Pellet Feeder- Direct Drive

New Ultra Feeder

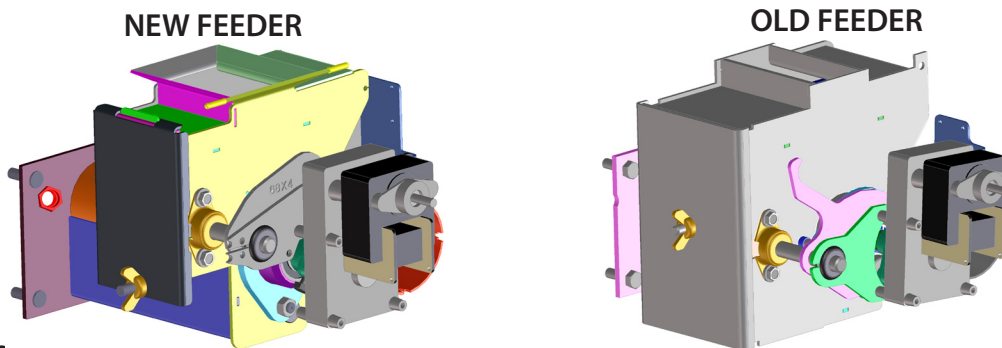
Compact Size. Service Friendly(increased internal visibility). Internal Airflow Built In.

The Ultra Feeder is a more compact design.

We've Increased the P68 feed motor to 6rpm with the Ultra Feeder. (4rpm motor originally)

The Ultra Feeder is sealed at the hopper throat with a replaceable gasket. No need for cutting silicone.

The Original feeder body cannot be replaced with an Ultra Feeder. Replacements for old feeders will remain available. Part# 1-10-677150.
